8th Edition (2023) Florida Building Code

Proposed Code Modifications

TAC: Electrical

Total Mods for **Electrical** in **Denied** : 6

FIGURE 905.1.2 ICE BARRIERS

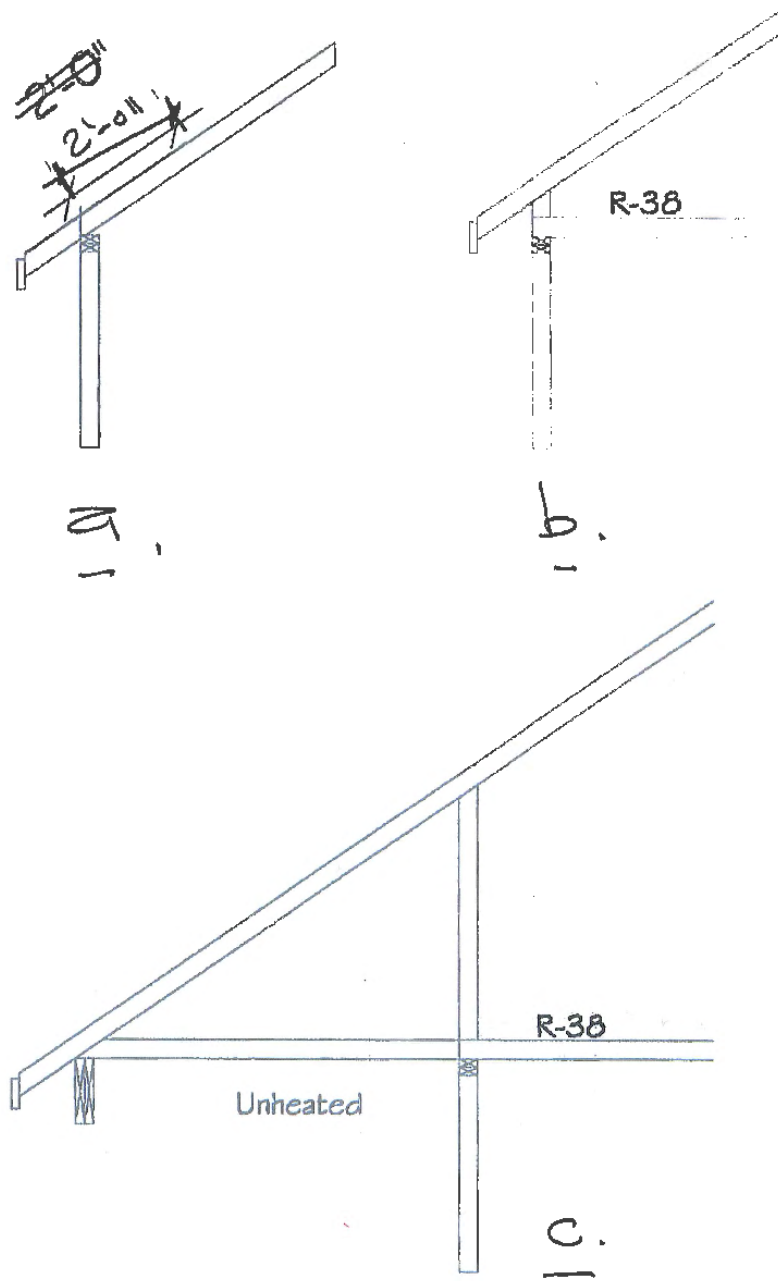
FOR OFFICE USE ONLY			
Received	11/16/2018	Code	2018 IRC
		Proposal number	#355
Code title		Edition	
International Residential Code		2018	
Section number and title		Page Number	
R905.1.2 Ice barriers			
Proponent		Representing (if applicable)	
Bill Kauffholz		Fischer Homes	
Address (number and street, city, state, and ZIP code)		Telephone number	
PROPOSED CODE CHANGE (check one)			
<input type="checkbox"/> Change to read as follows <input type="checkbox"/> Add to read as follows <input checked="" type="checkbox"/> Delete and substitute as follows <input type="checkbox"/> Delete without substitution			
<p>R905.1.2 Ice barriers</p> <p>An ice barrier shall be installed for asphalt shingles, metal roof shingles, mineral-surfaced roll roofing, slate and slate-type shingles, wood shingles and wood shakes. The ice barrier shall consist of not fewer than two layers of underlayment cemented together, or a self-adhering polymer-modified bitumen sheet shall be used in place of normal underlayment and extend from the lowest edges of all roof surfaces to a point not less than 24 inches (610 mm) outside the exterior wall line of the building. The 24 inch measurement shall be along the slope of the roof from the point where the projected outside face of the wall intersects the roof deck. See Figure 905.1.2 (a). On roofs with slope equal to or greater than eight units vertical in 12 units horizontal (67-percent slope), the ice barrier shall also be applied not less than 36 inches (914 mm) measured along the roof slope from the eave edge of the building.</p> <p>Exception 1: Detached accessory structures not containing conditioned floor area</p> <p>Exception 2: If an attic/roof section is insulated to a minimum of R-38 uncompressed over the outside face of the exterior wall</p> <p>See pg. 2 for Figure 905.1.2 Ice barriers</p>

FIGURE 905.1.2 ICE BARRIERS

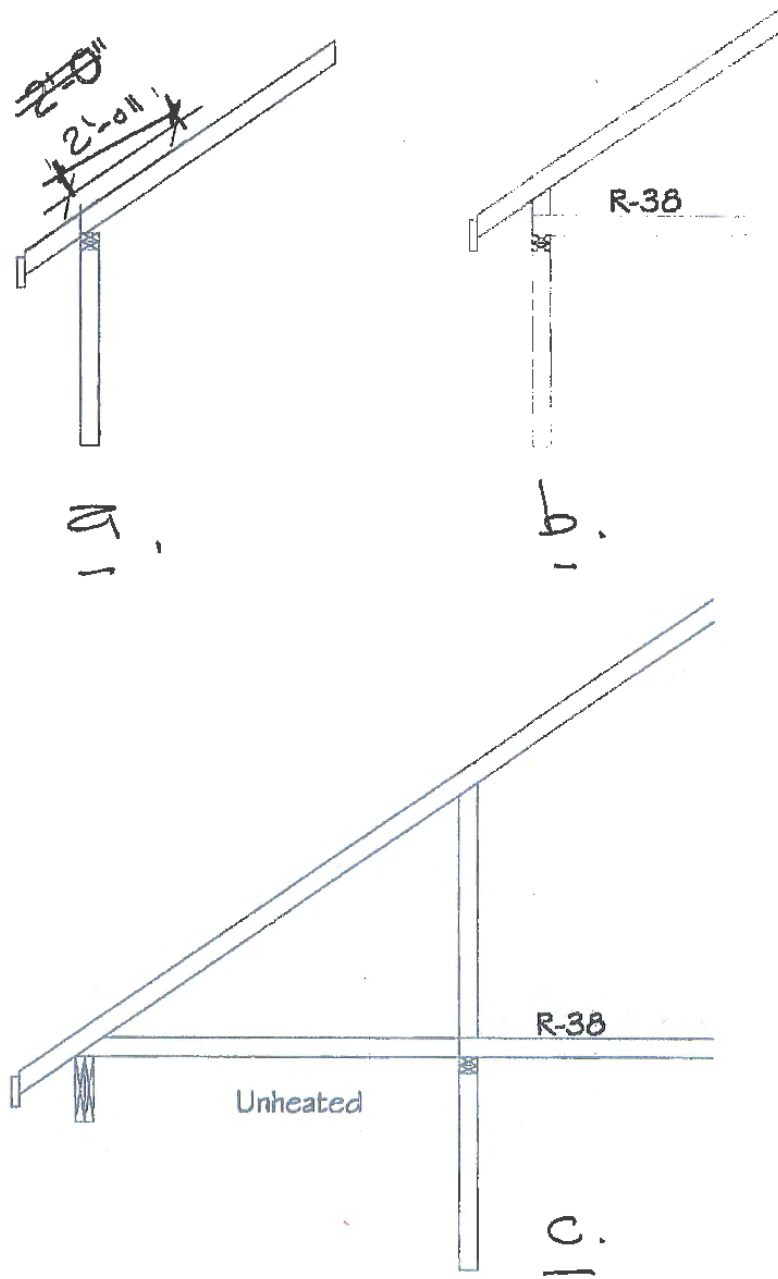
FOR OFFICE USE ONLY			
Received	11/16/2018	Code	2018 IRC
		Proposal number	#355
Code title		Edition	
International Residential Code		2018	
Section number and title		Page Number	
R905.1.2 Ice barriers			
Proponent		Representing (if applicable)	
Bill Kauffholz		Fischer Homes	
Address (number and street, city, state, and ZIP code)		Telephone number	
PROPOSED CODE CHANGE (check one)			
<input type="checkbox"/> Change to read as follows <input type="checkbox"/> Add to read as follows <input checked="" type="checkbox"/> Delete and substitute as follows <input type="checkbox"/> Delete without substitution			
<p>R905.1.2 Ice barriers</p> <p>An ice barrier shall be installed for asphalt shingles, metal roof shingles, mineral-surfaced roll roofing, slate and slate-type shingles, wood shingles and wood shakes. The ice barrier shall consist of not fewer than two layers of underlayment cemented together, or a self-adhering polymer-modified bitumen sheet shall be used in place of normal underlayment and extend from the lowest edges of all roof surfaces to a point not less than 24 inches (610 mm) outside the exterior wall line of the building. The 24 inch measurement shall be along the slope of the roof from the point where the projected outside face of the wall intersects the roof deck. See Figure 905.1.2 (a). On roofs with slope equal to or greater than eight units vertical in 12 units horizontal (67-percent slope), the ice barrier shall also be applied not less than 36 inches (914 mm) measured along the roof slope from the eave edge of the building.</p> <p>Exception 1: Detached accessory structures not containing conditioned floor area</p> <p>Exception 2: If an attic/roof section is insulated to a minimum of R-38 uncompressed over the outside face of the exterior wall</p> <p>See pg. 2 for Figure 905.1.2 Ice barriers</p>
